06-467r3: SAS-2 Initiator handling of retransmit read DATA frames

To: T10 Technical Committee
From: Bob Sheffield (Robert.L.Sheffield@intel.com)
Vicky Duerk (vicky.p.duerk@intel.com)
Date: 12 March 2007
Subject: SAS-2: Initiator handling of retransmit read DATA frames

Figure 1 — Representation of transport layer (i.e., ST_TTS6) read data operation

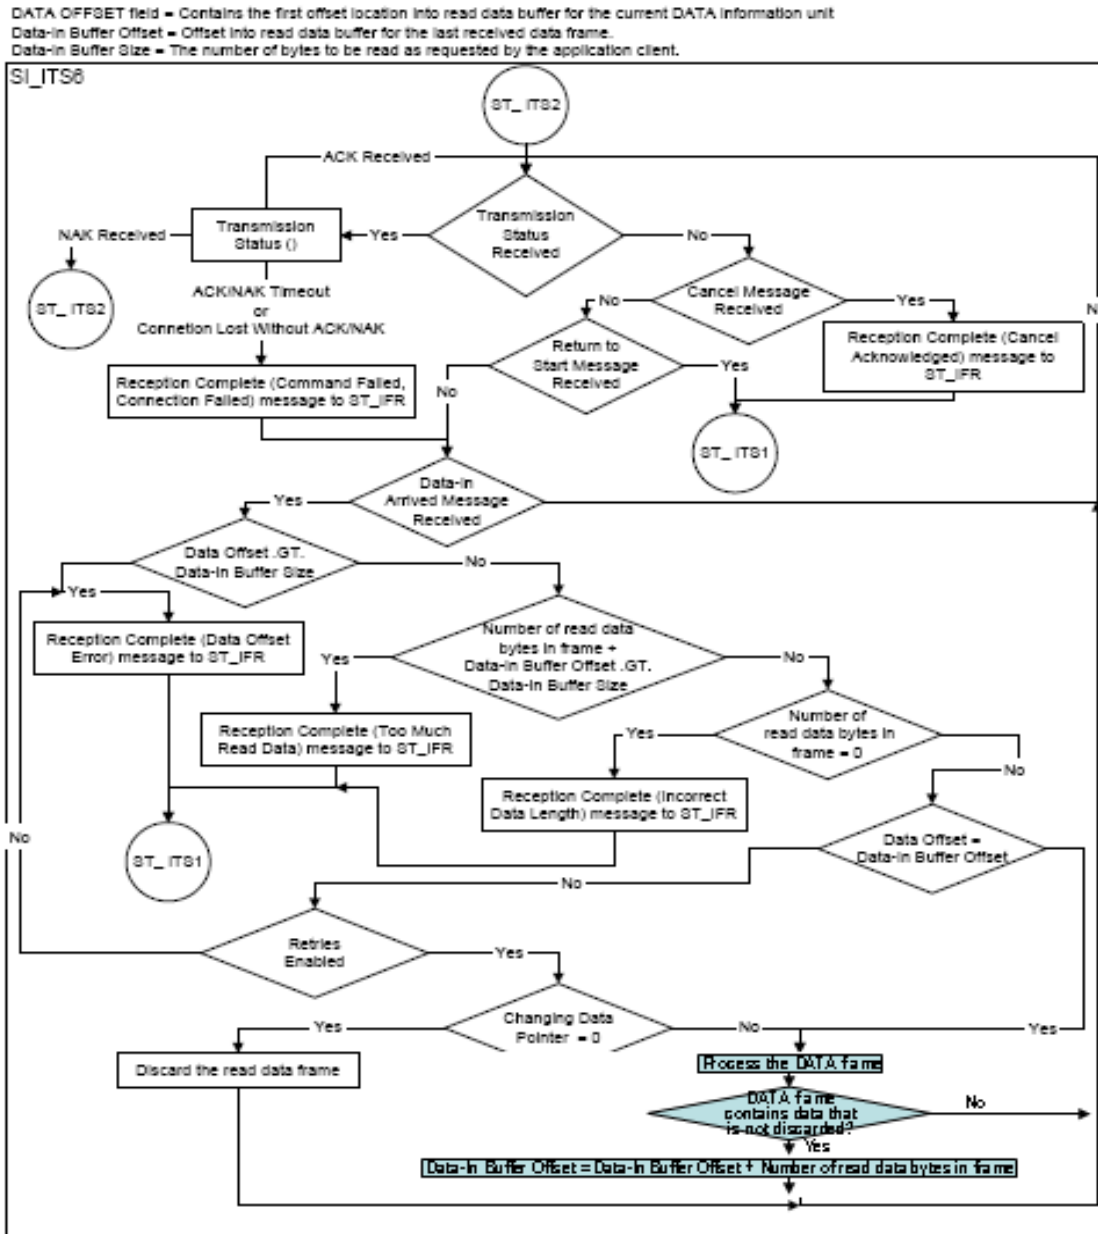
The flow chart in 06-489r0 should be modified as shown in the following figure:
